ARCHITECTURAL REVIEW BOARD MEETING

PROJECT COMMENTS

DATE: 12/19/2022

PROJECT NUMBER: SP2022-057
PROJECT NAME: Site Plan for DuWest Phase 2
SITE ADDRESS/LOCATIONS: 3000 N GOLIAD ST

CITY SITE PLAN

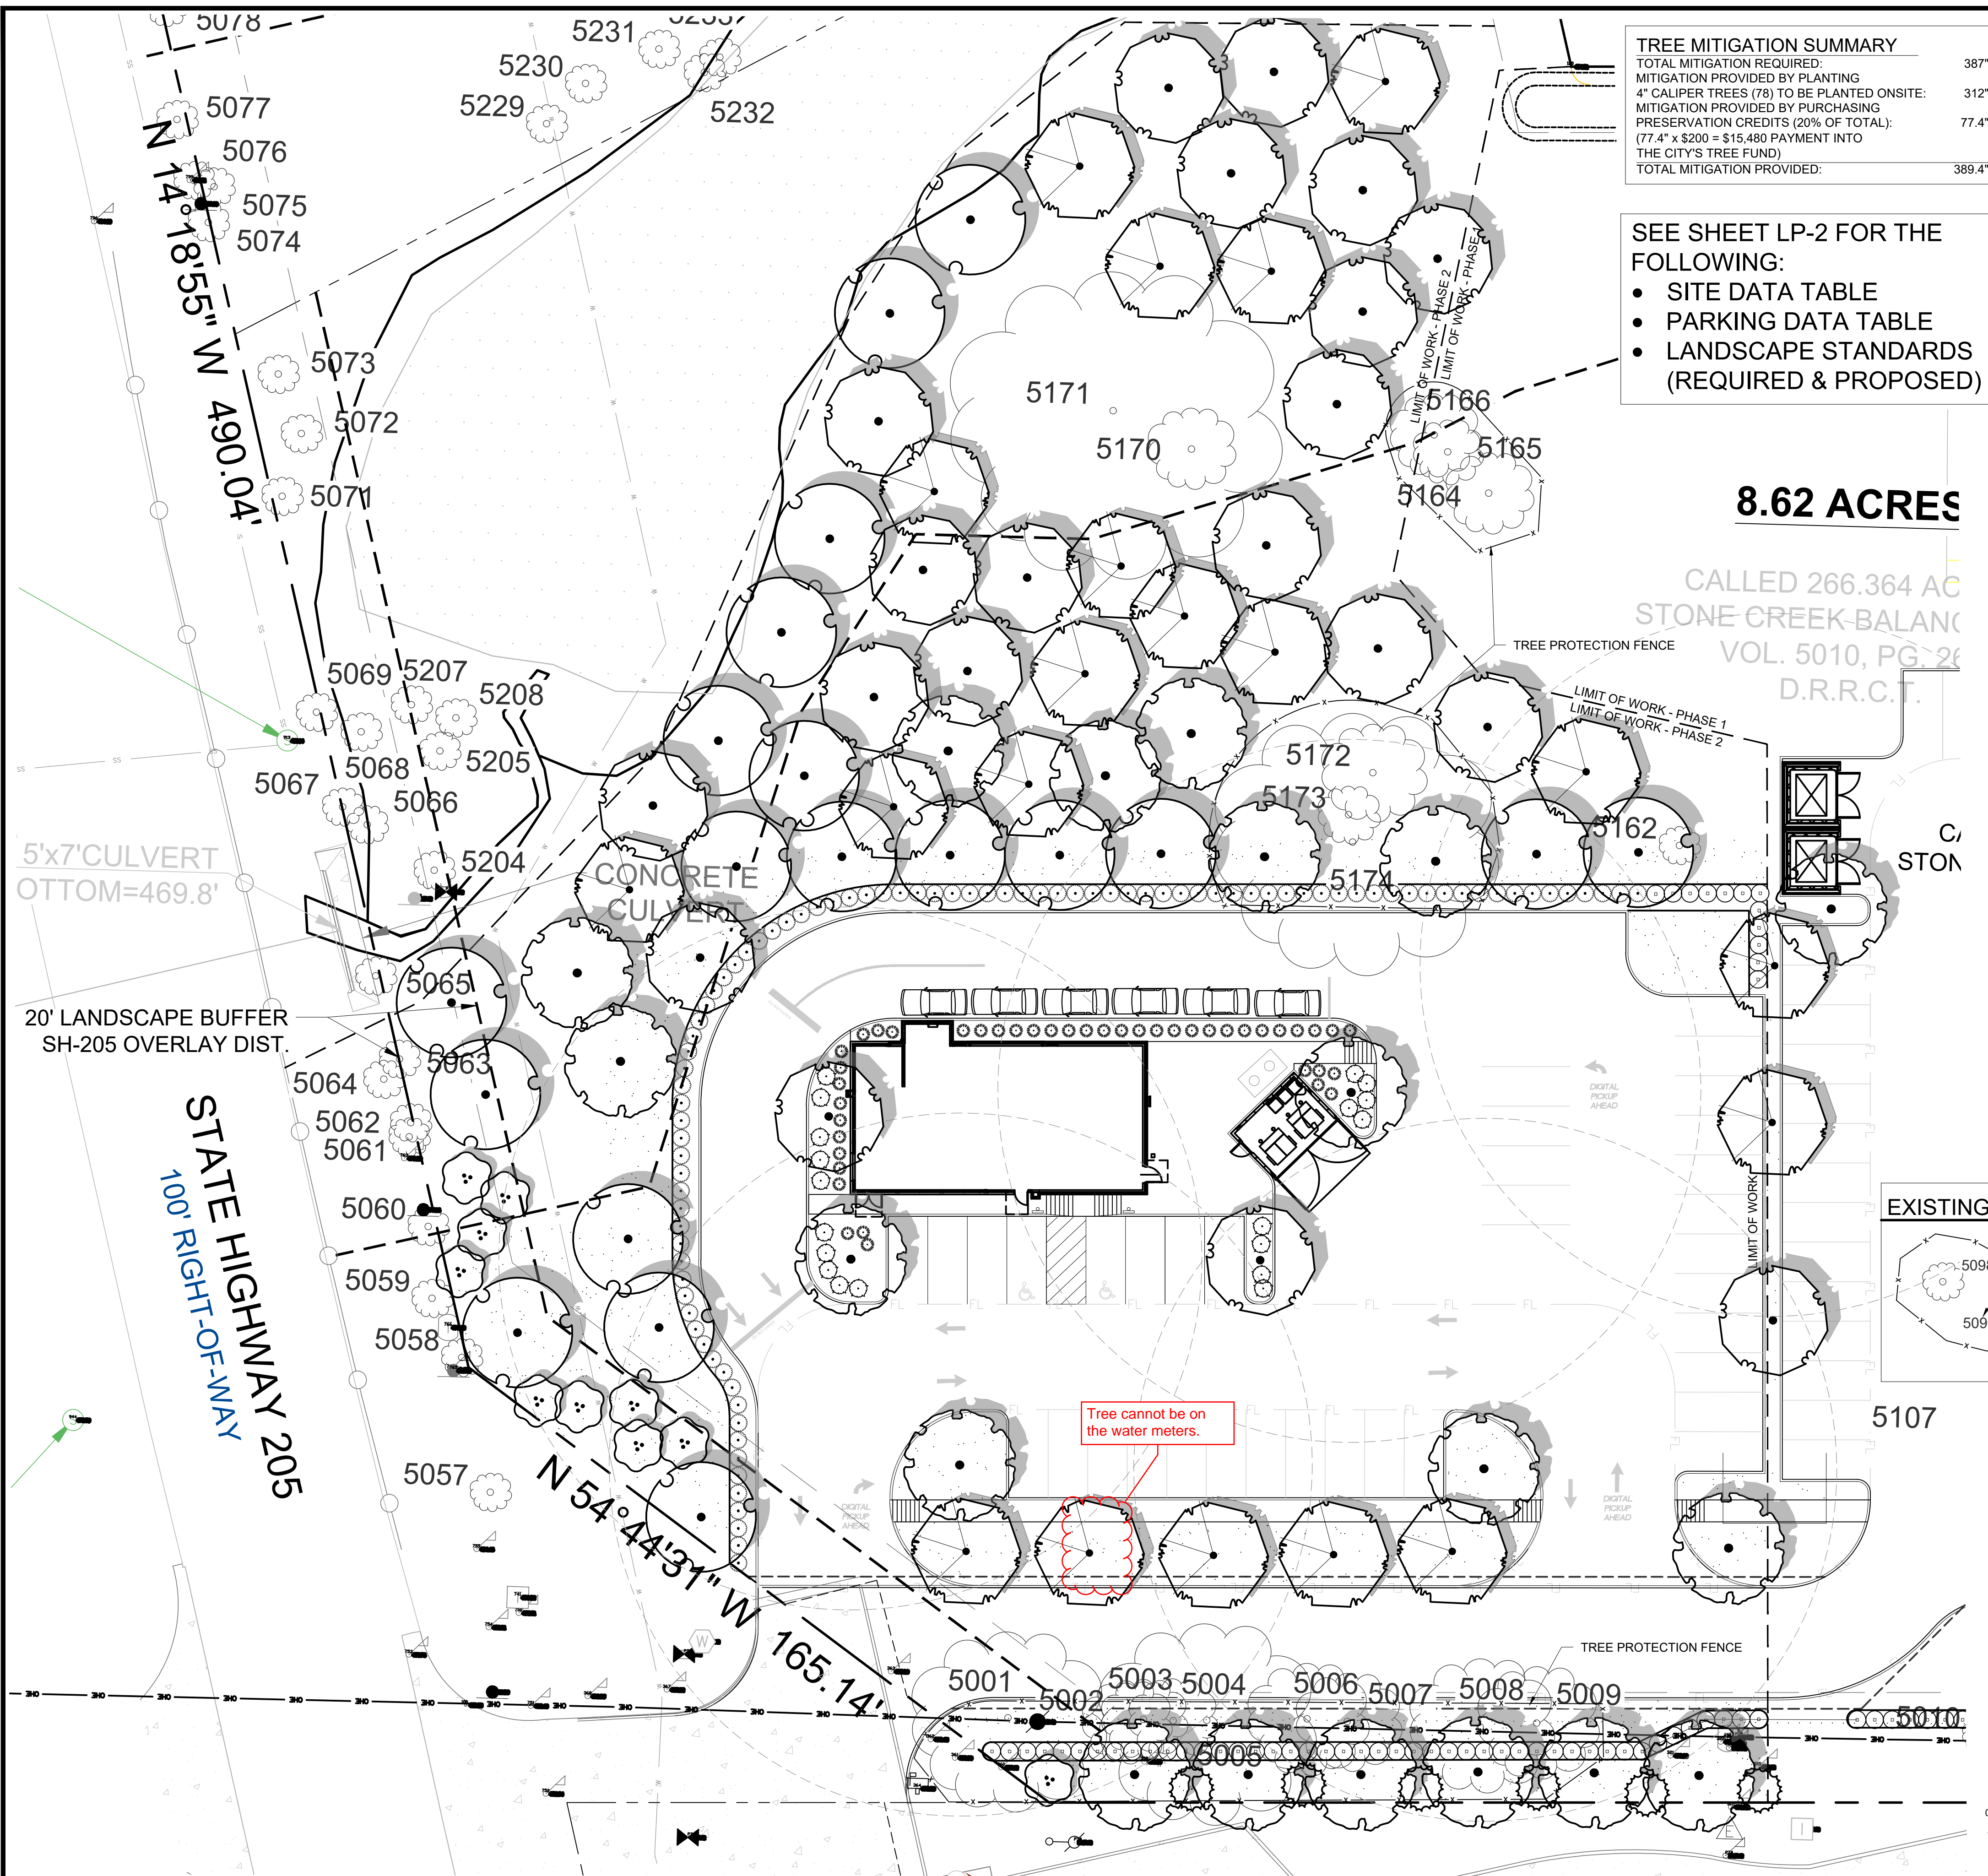
- (7) Please label N. Goliad Street; this is to provide reference on the site plan. (Subsection 03.04. B, of Article 11)
- (8) Within the parking table please indicate the parking required for the patio. Outdoor seating is calculated as one (1) parking space per four (4) seats. (Subsection 05.01, of Article 06)

- (13) Please clarify the marking board. (Subsection 03.04. B, of Article 11)
- (14) Please provide a sidewalk from the site to the amenity area to the north-east. (Planned Development District 70)

LANDSCAPE PLANTING PLAN

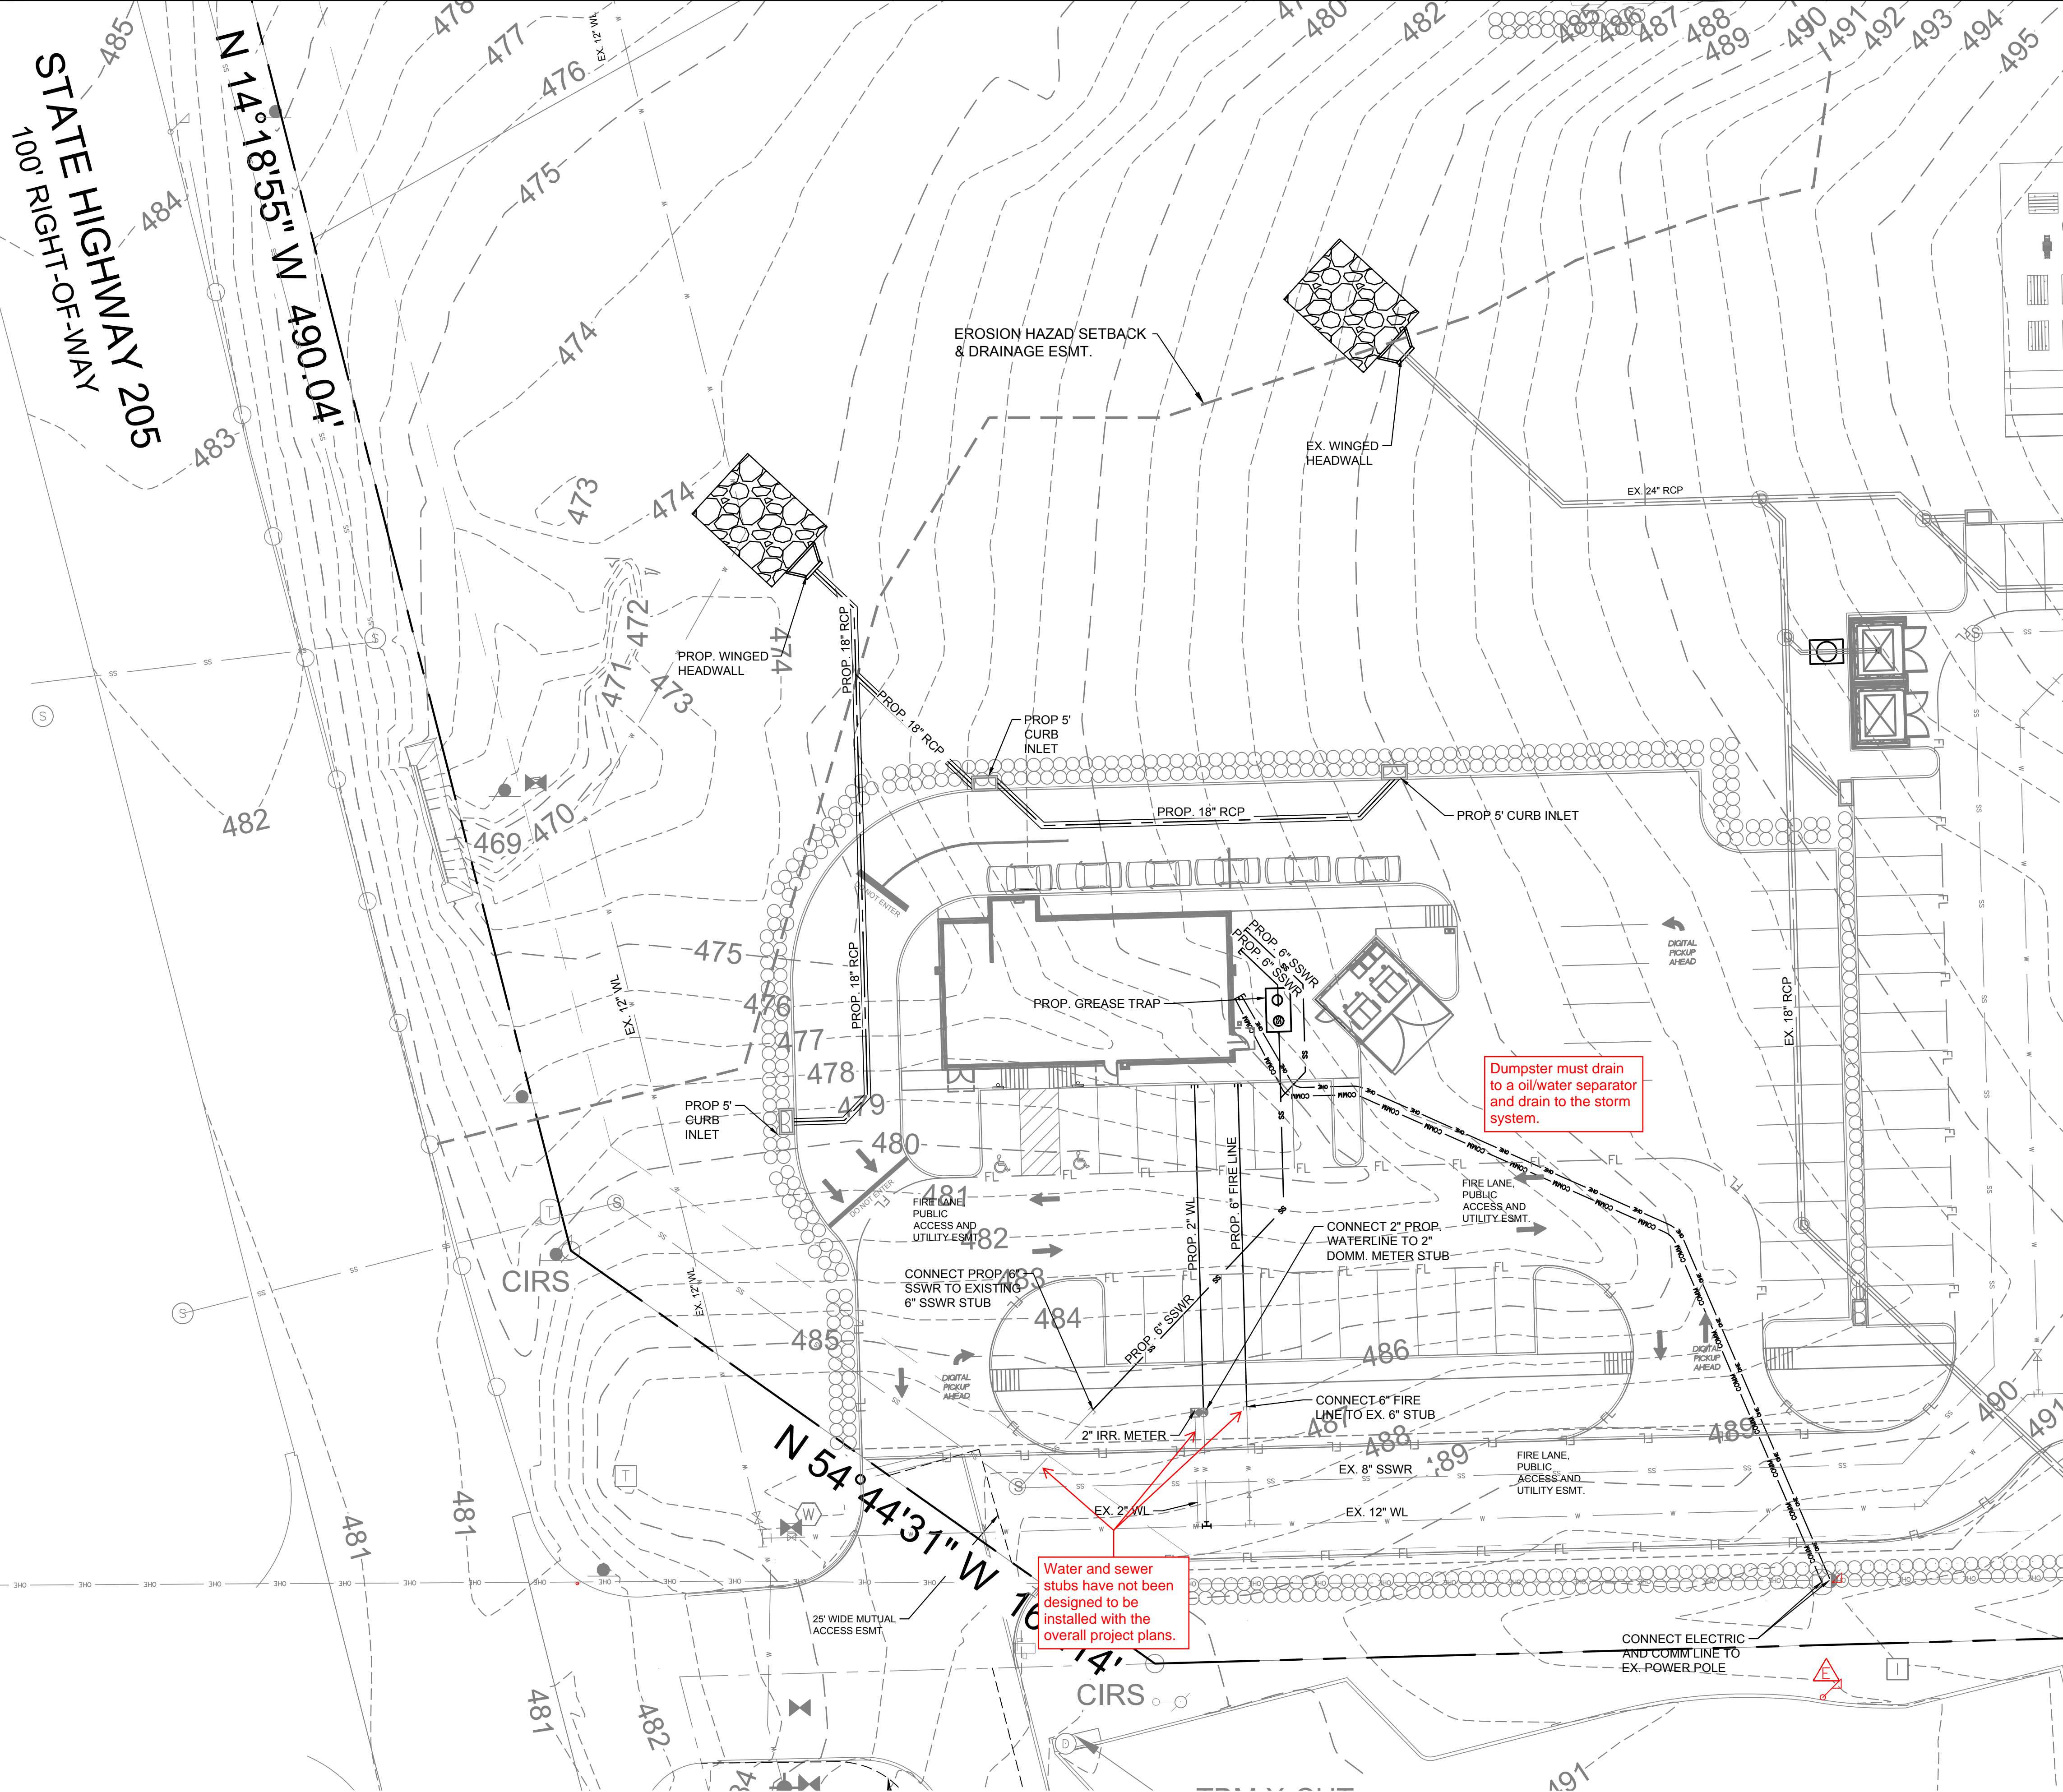
- (1) Shrubs must be provided along the east property line to screen for headlights. (Subsection 05.03. B, of Article 08)
- (2) All shrubs must be five (5) gallon. (Subsection 05.03. B, of Article 08)
- (3) The patio indicated on the site plan has plantings within it on the landscape plan. Please clarify if there will be a patio or if this area will be landscaped. (Subsection 05.03, of Article 08)
